**DEQ Coal Combustion Residuals
Surface Impoundment
Closure Determination**

Marshall Steam Station

April 1, 2019

CROSS SECTION A-A' (VIEWED FROM SW SIDE OF DAM LOOKING NE)

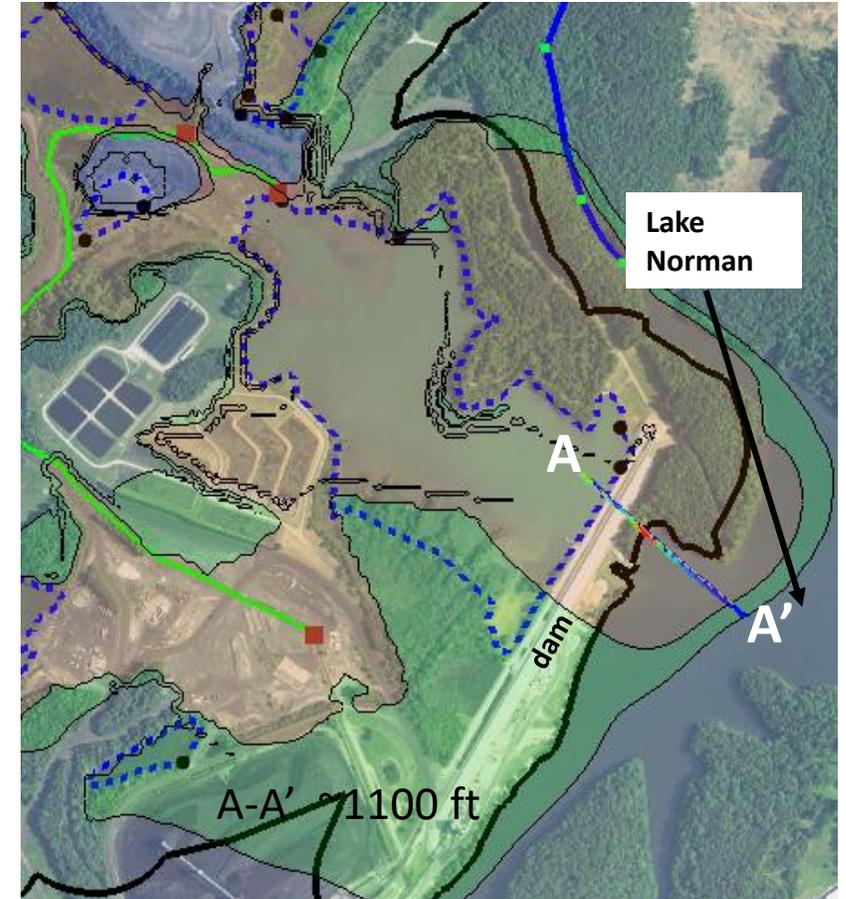
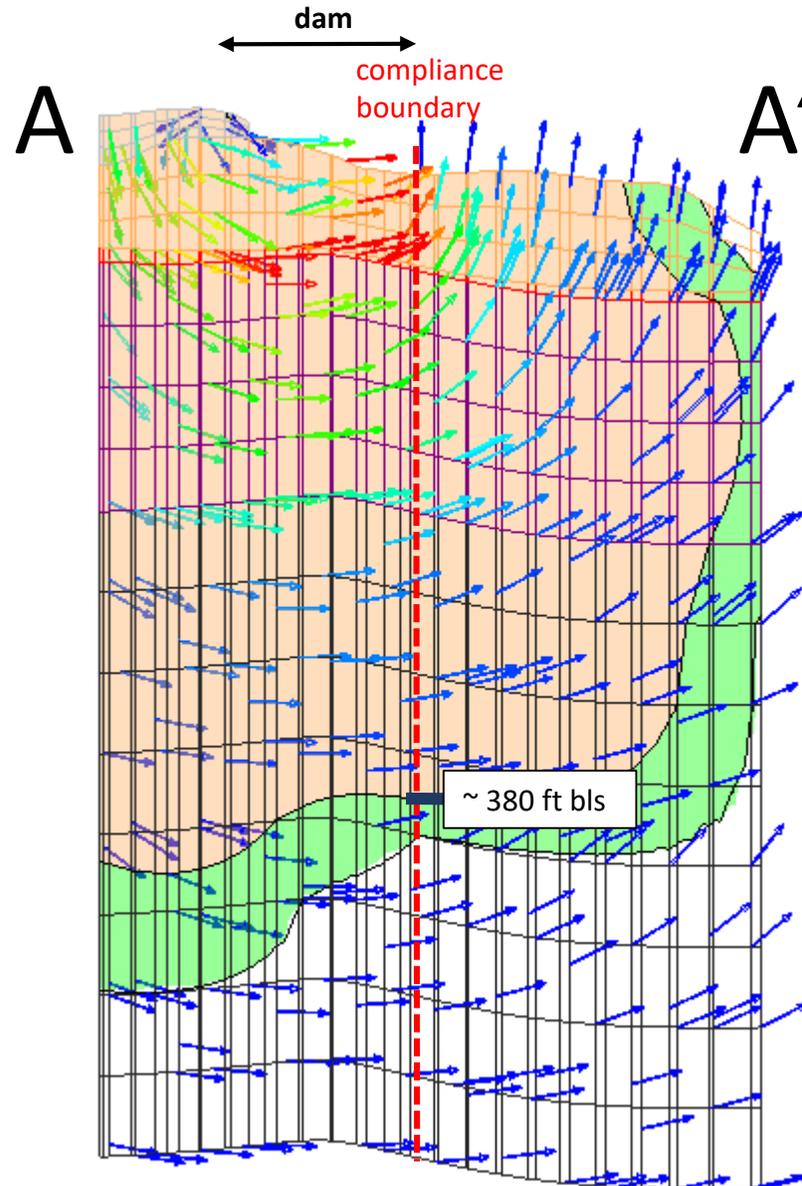
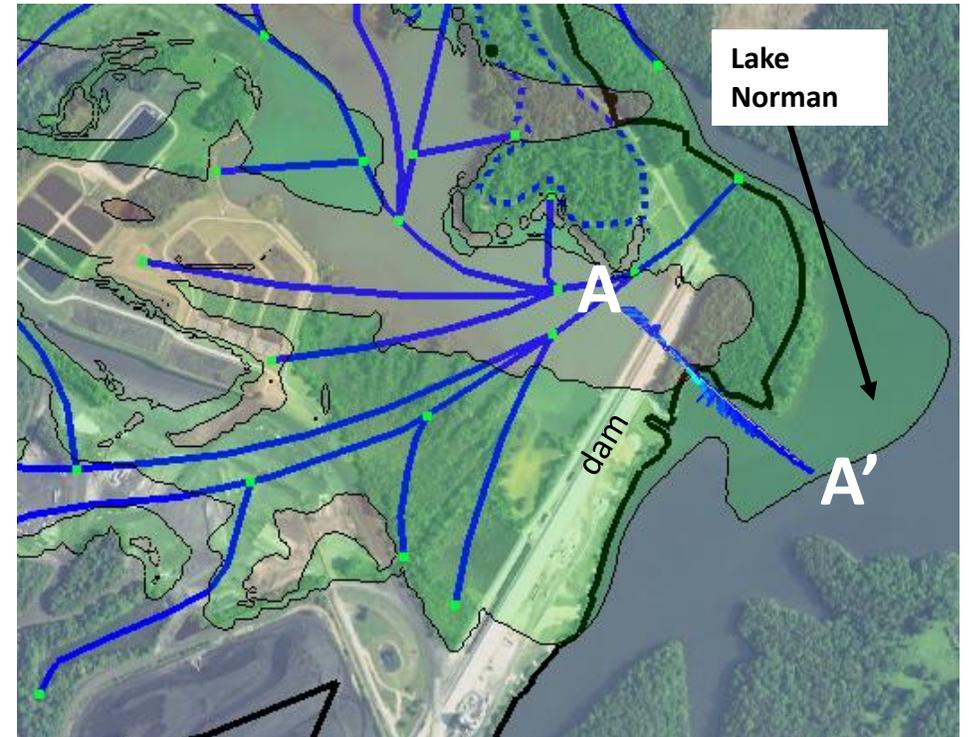
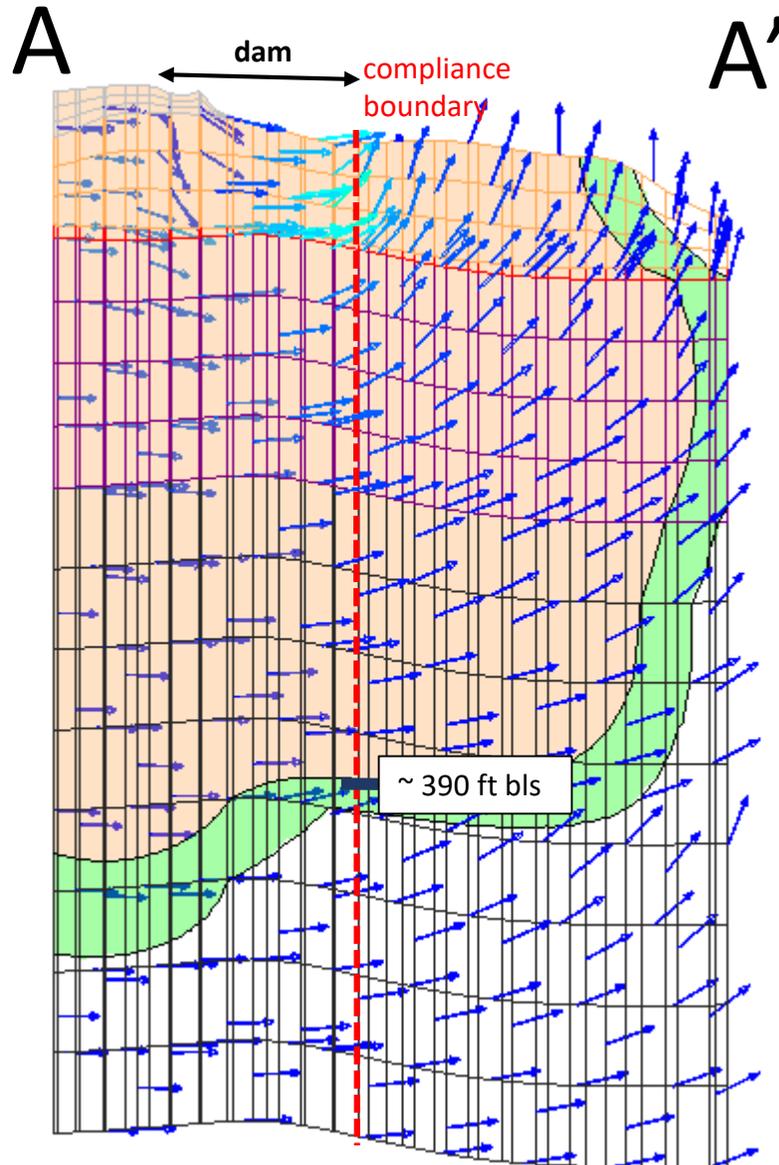
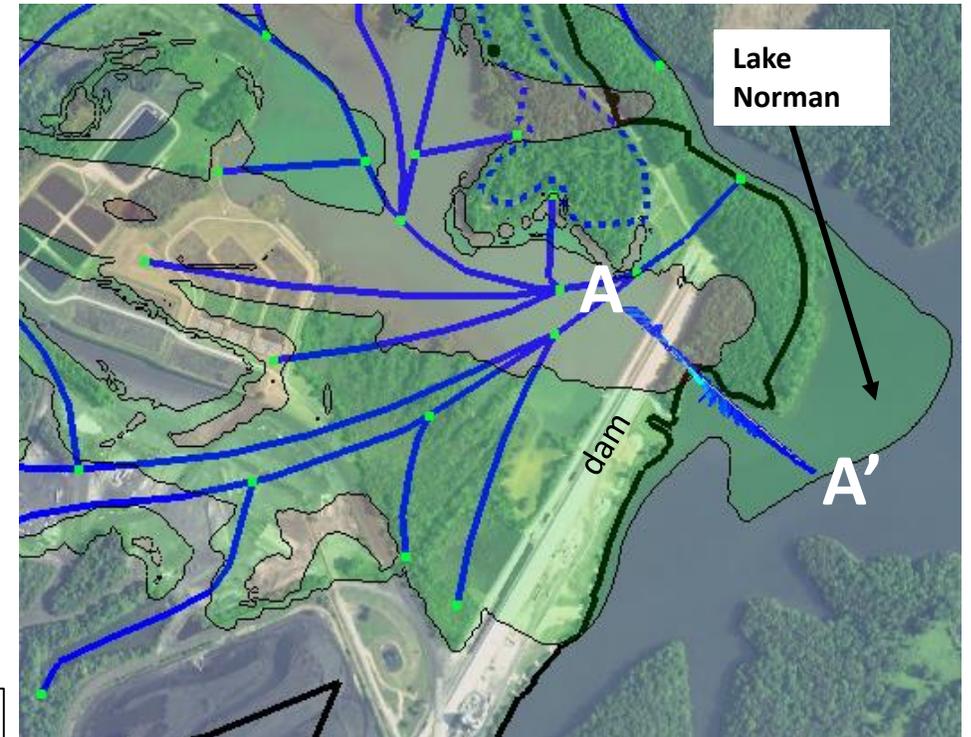
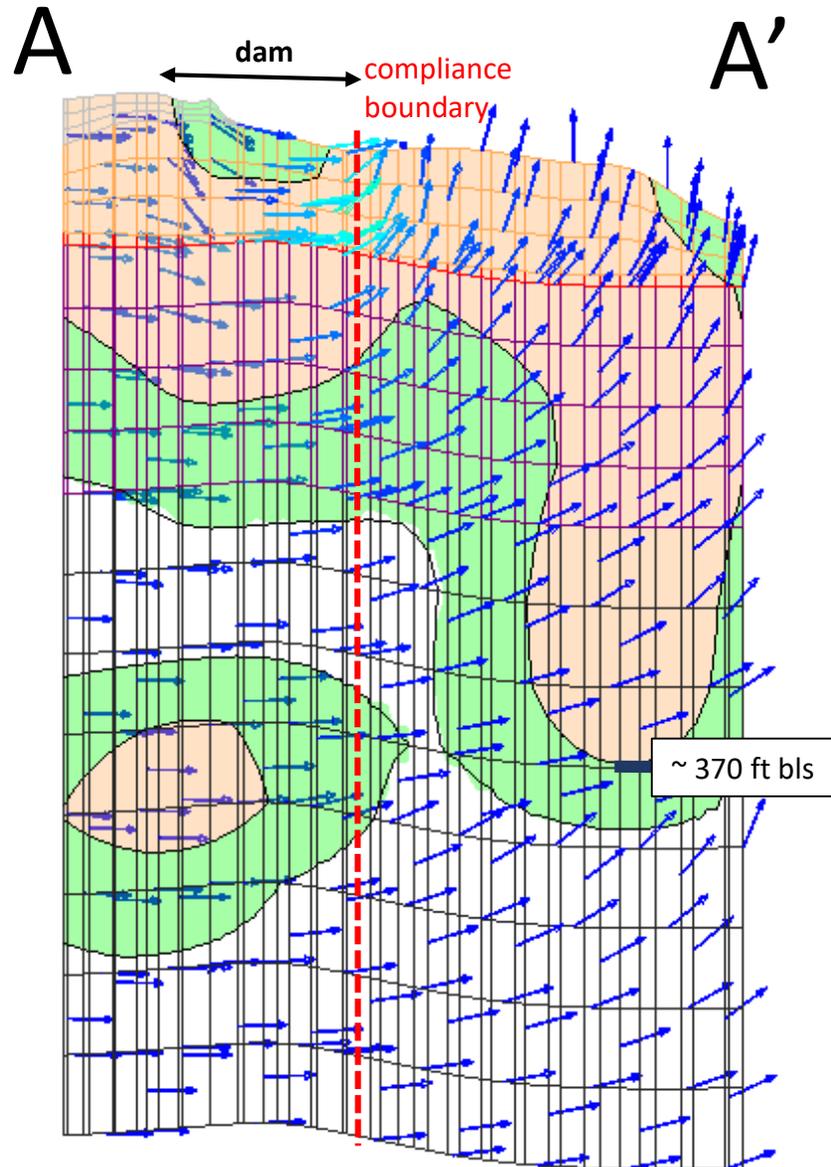
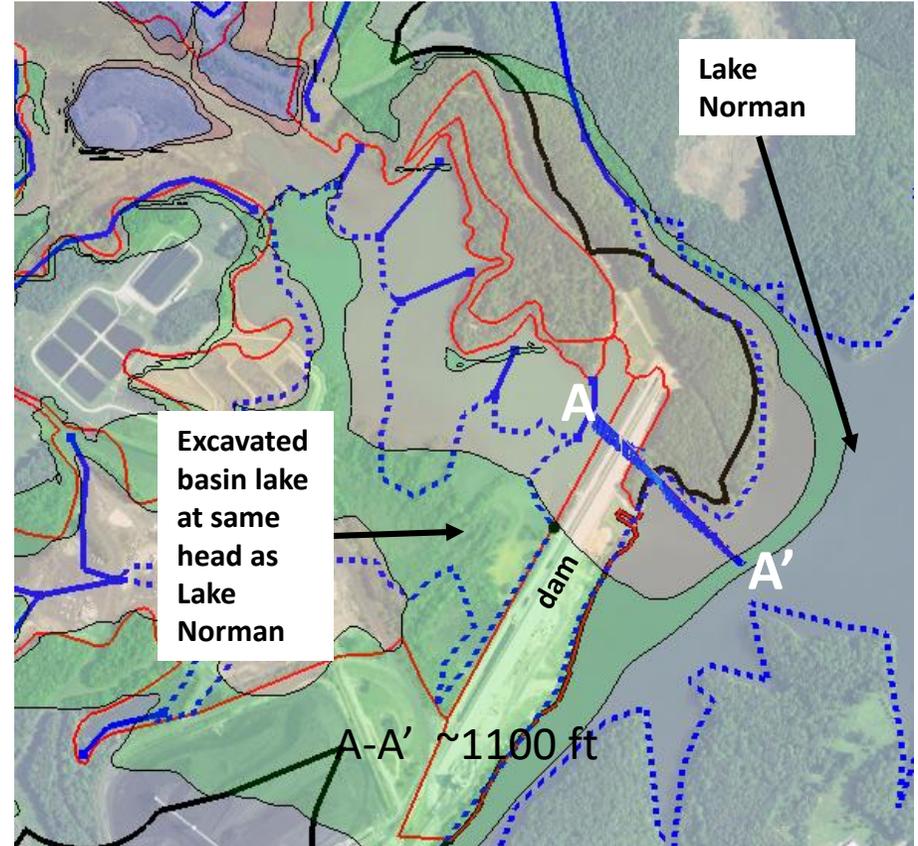
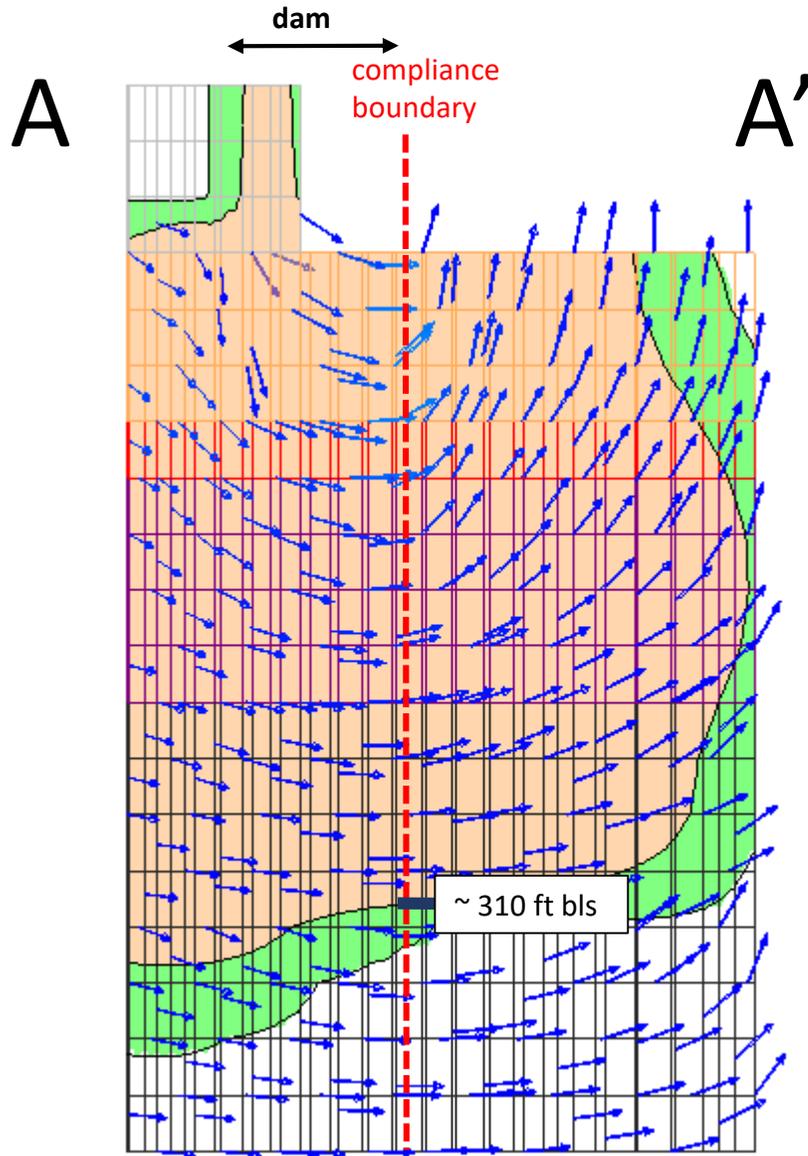
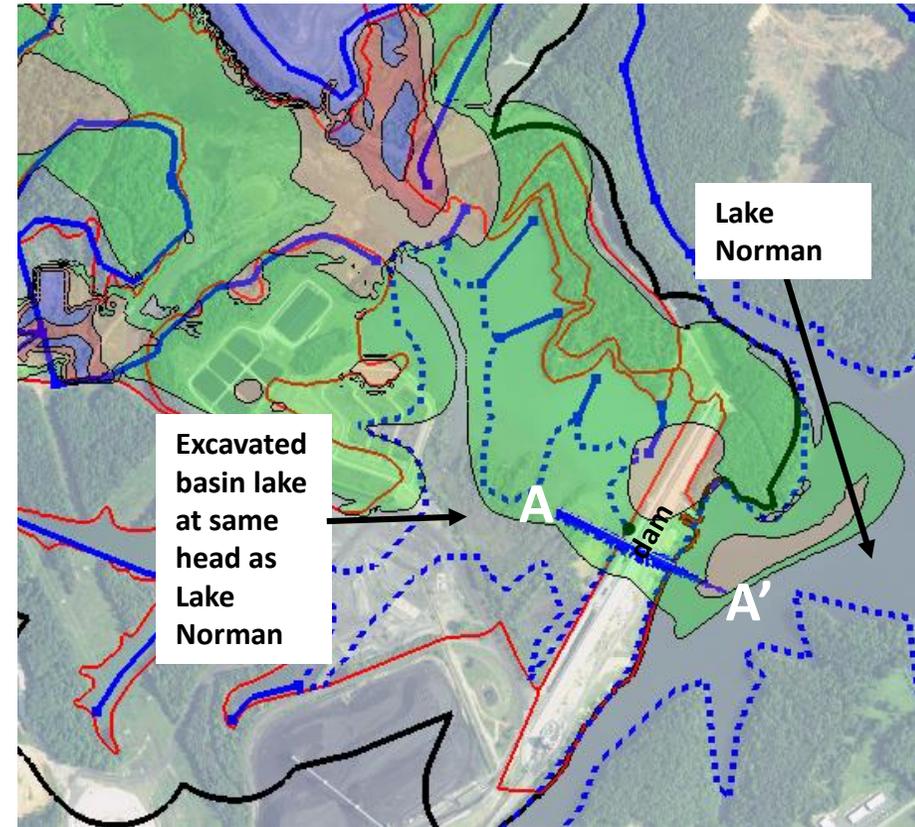
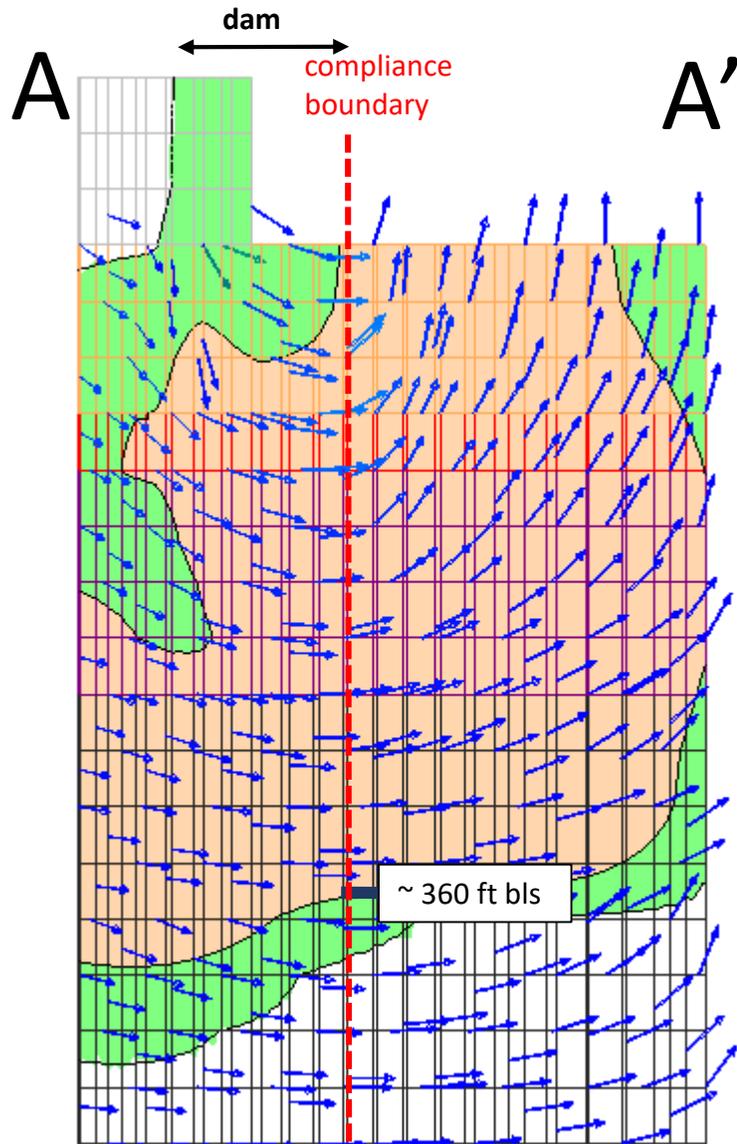
DEQ evaluated cross-sections of the groundwater modeling results provided by Duke Energy to determine whether Duke Energy’s final closure *Option 1: Hybrid* and *Option 5: Closure-in-Place* would meet the criteria of CAMA Option B. DEQ considered if the agency could conclude that the proposed closure option includes design measures to prevent any post closure exceedances of the 2L groundwater quality standards at the compliance boundary upon the plan’s full implementation. Cross section A-A’ was evaluated and can be seen in the figures below. This cross section represents where the boron concentration above the 2L standard of 700 µg/L has crossed the compliance boundary based on groundwater monitoring and modeling.

The table below summarizes the results from the model simulations. The boron concentrations depicted in the table represent the maximum boron concentration in any layer (ash, saprolite, transition zone, and bedrock) of the model.

Marshall Modeling Results for Cross-Section A-A’			
Model Simulation	Maximum Concentration of Boron Above 2L Beyond Compliance Boundary (ug/L)	Depth of GW Contamination Above 2L Beyond Compliance Boundary (feet bgs)	Width of Contamination Plume Beyond Compliance Boundary (feet)
Current Conditions	700-4,000	380	1500
Completion of Final Cover (t=0 yrs)	700-4,000	390	1500
Final Cover (t=120 yrs)	700-4,000	370	1500
Completion of Hybrid (t=0 yrs)	700-4,000	310	1500
Hybrid (t=120 yrs)	700-4,000	360	1600

These data illustrate that after completion of closure with the final cover or hybrid option, the groundwater plume still extends beyond the compliance boundary above the 2L groundwater standard and the area of the plume requiring remediation is immense. Even 120 years beyond completion of closure, the area of the plume requiring remediation remains extensive.

DEQ recognizes that there are no groundwater remediation corrective actions included in the groundwater modeling simulations submitted to DEQ as part of Duke Energy’s closure options analysis documentation. However, based on the current geographic scope, vertical extent of the groundwater contamination plume, and future modeled extent of the plume, DEQ does not believe these two closure options can meet the requirements of CAMA Option B.
